# CROSSROADS NORTH

## PRELIMINARY PLAN

PRELIM PLAN 1  
SHEET 02 OF 12

# v4\_Preliminary Plan\_Comments.pdf Markup Summary

### SHEET 3 SPECIFIC NOTES

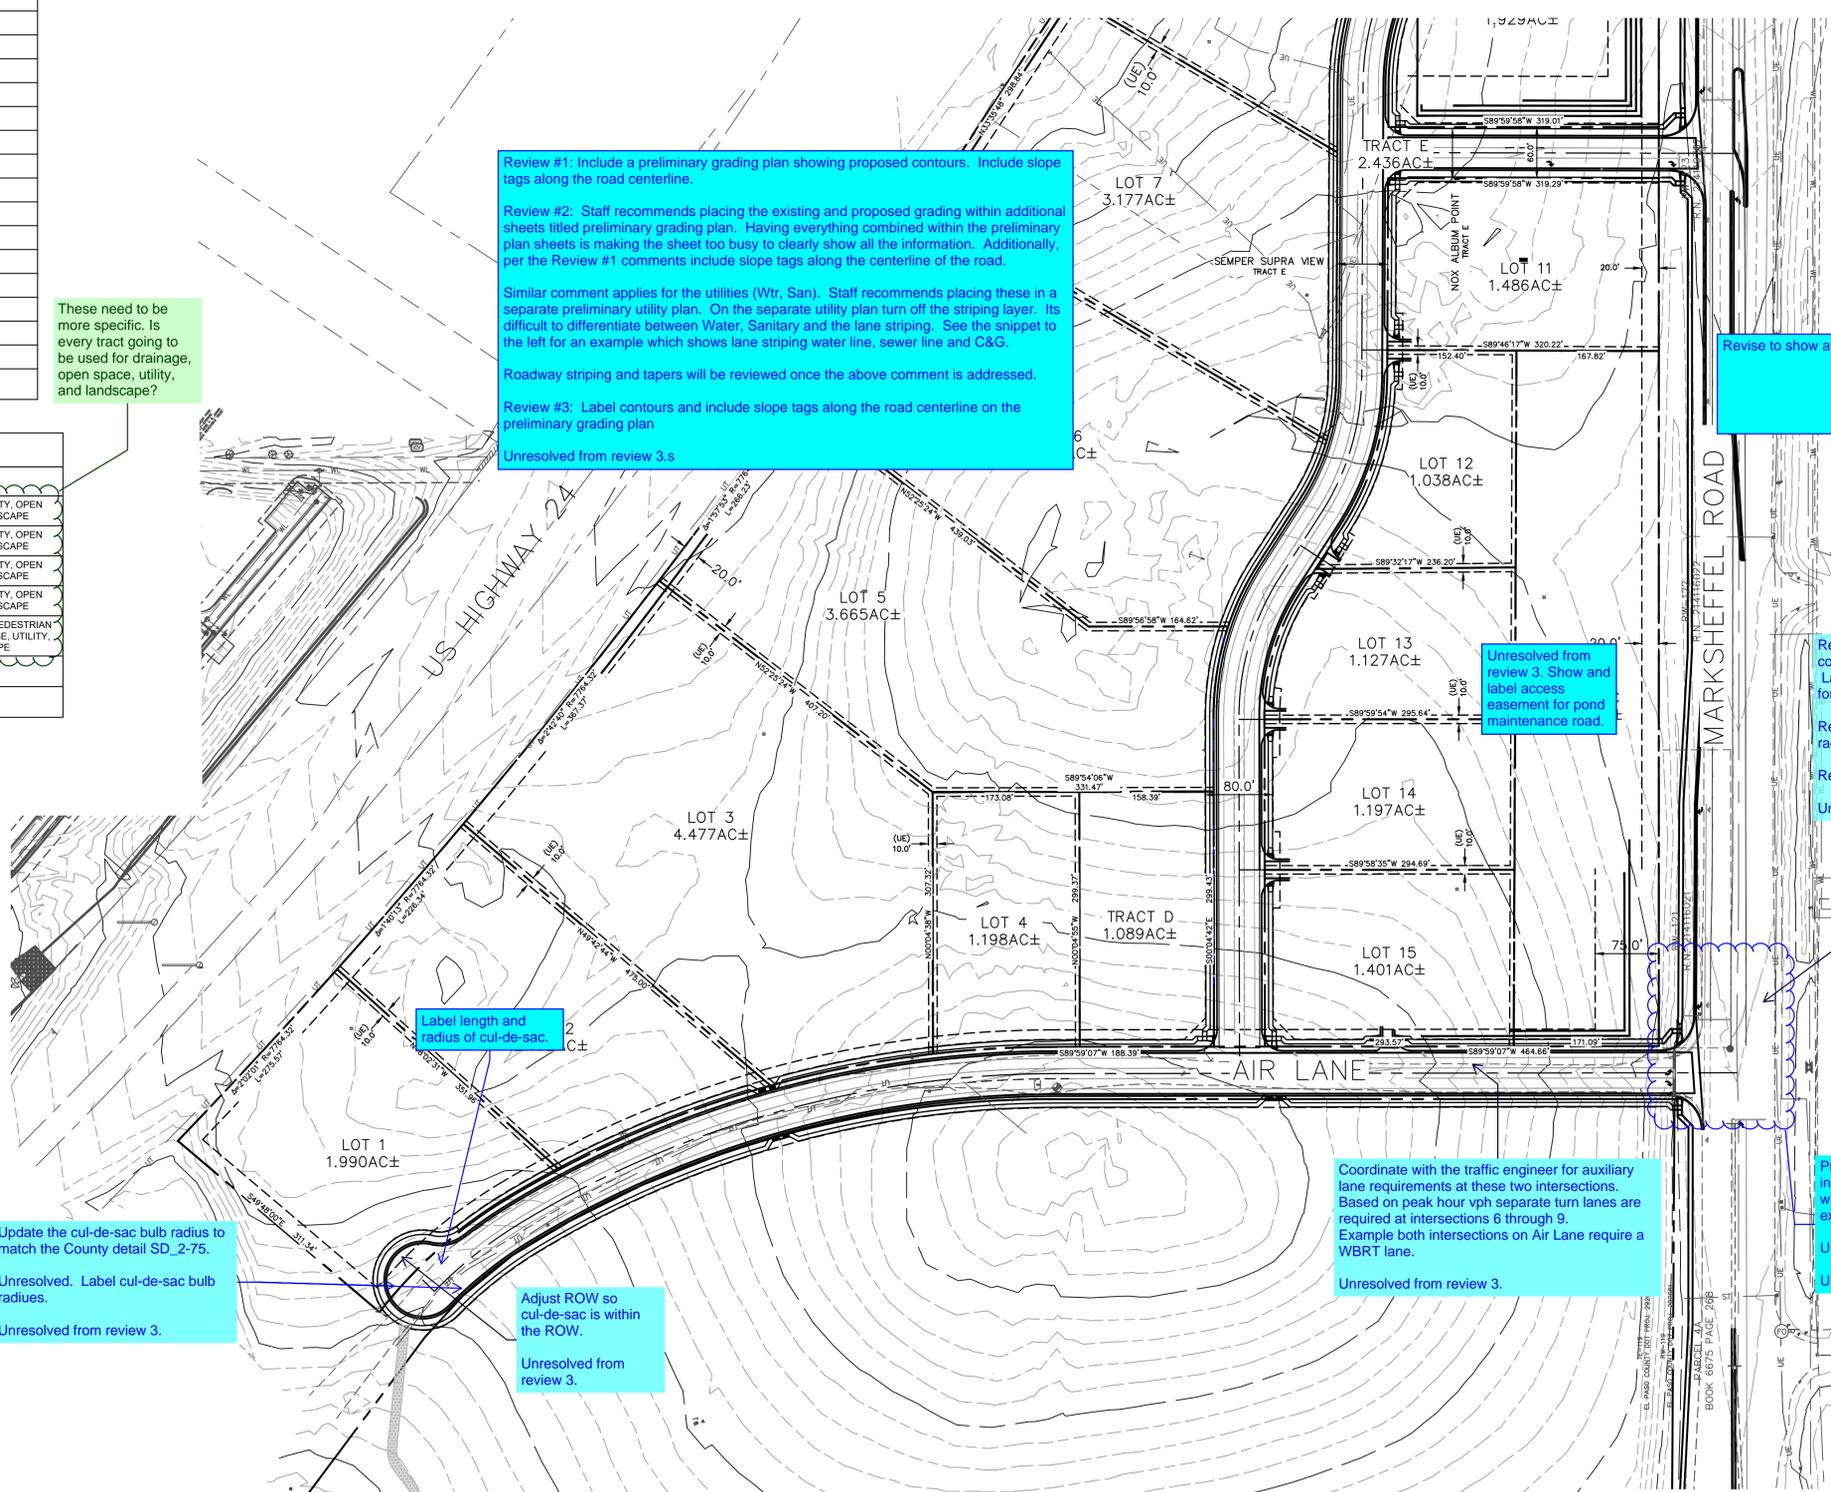
This note doesn't appear to match with the actual plan. Are these lots not obtaining access off of Air Lane?

Please depict any cistern or fire hydrant locations on the plan.

Update the cul-de-sac bulb radius to match the County detail SD\_2-75.  
Unresolved. Label cul-de-sac bulb radii.  
Unresolved from review 3.

Label length and radius of cul-de-sac.

Adjust ROW so cul-de-sac is within the ROW.  
Unresolved from review 3.

Review #1: Include a preliminary grading plan showing proposed contours. Include slope tags along the road centerline.  
Review #2: Staff recommends placing the existing and proposed grading within additional sheets titled preliminary grading plan. Having everything combined within the preliminary plan sheets is making the sheet too busy to clearly show all the information. Additionally, per the Review #1 comments include slope tags along the centerline of the road.  
Similar comment applies for the utilities (Wtr, San). Staff recommends placing these in a separate preliminary utility plan. On the separate utility plan turn off the striping layer. Its difficult to differentiate between Water, Sanitary and the lane striping. See the snippet to the left for an example which shows lane striping water line, sewer line and C&G.  
Roadway striping and tapers will be reviewed once the above comment is addressed.

Review #3: Label contours and include slope tags along the road centerline on the preliminary grading plan  
Unresolved from review 3.s

Revise to show aux lanes required per TIS.

Unresolved from review 3. Show and label access easement for pond maintenance road.

Review #1: Show the proposed roadway configuration of Air Lane and the intersection. Label the curb return radius. See Table 2-31 for minimum curb return radius.  
Review #2: Unresolved. Label the curb return radius.  
Review #3: Unresolved.  
Unresolved from review 3. s

Coordinate with the traffic engineer for auxiliary lane requirements at these two intersections. Based on peak hour vph separate turn lanes are required at intersections 6 through 9. Example both intersections on Air Lane require a WBRT lane.  
Unresolved from review 3.

Provide a larger detailed preliminary grading at the intersection. There appears to be drainage issues with two existing culverts, proposed sidewalk and existing roadside ditch.  
Unresolved.  
Unresolved from review 3.
